From: Blair, Ruth [mailto:Ruth.Blair@balfourbeatty.com]
Sent: 26 February 2019 16:44
To: Low, Scott
Cc: Hockenhull, Joel
Subject: 190178 - Brook Farm, Quarry Lane, Gorsley, Ross-On-Wye, HR9 7SH comments

SITE: Brook Farm, Quarry Lane, Gorsley, Ross-On-Wye, HR9 7SH
TYPE: Discharge of Conditions
DESCRIPTION: Application for approval of details reserved by conditions 2, 6 & 8 attached to planning permission 182770 (extension to yard and new workshop)
APPLICATION NO: 190178
GRID REFERENCE: OS 367743, 225840
APPLICANT: Mr Harper
AGENT: Mr Luke Hemming

Figure 1: Environment Agency Flood Risk from Surface Water map, February 2019

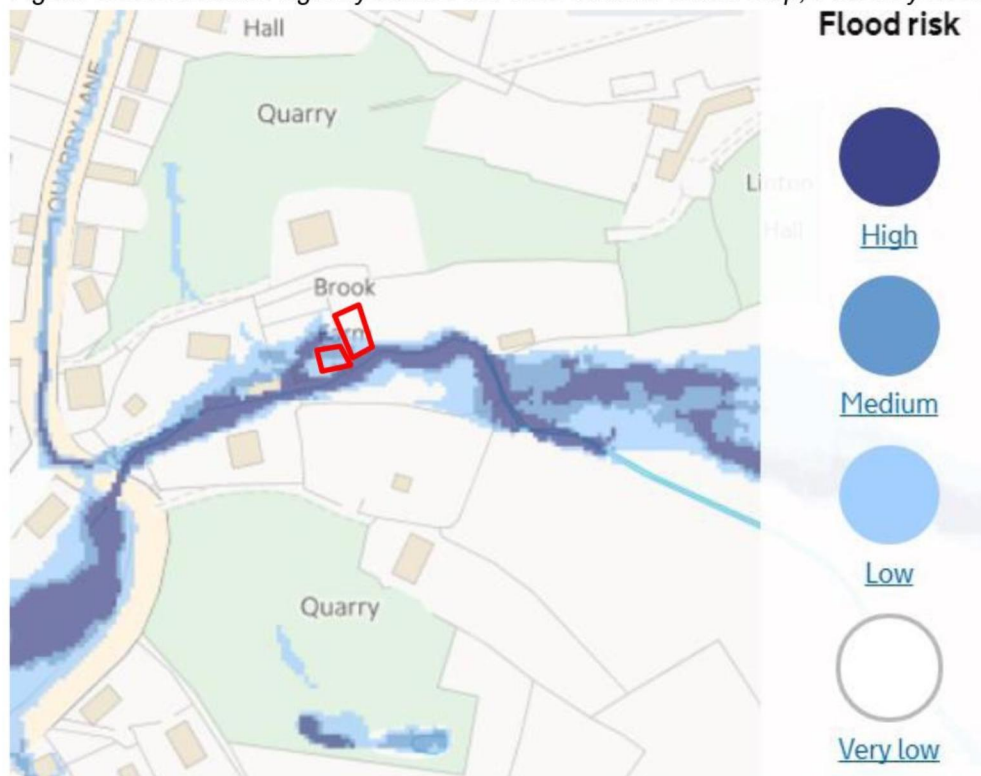
Please note that we were not consulted at the planning permission stage. The proposed location of the development is at risk of surface water flooding.

We appreciate that the relevant condition is relating to the surface water runoff management, however the risk as demonstrated above should be mitigated. We were not consulted at the planning permission stage so were unable to raise this risk before permission was granted and thus could not request a condition was added to mitigate the risk of surface water flooding.

We recommend that the floor levels of the development are raised to mitigate the risk of flooding here.
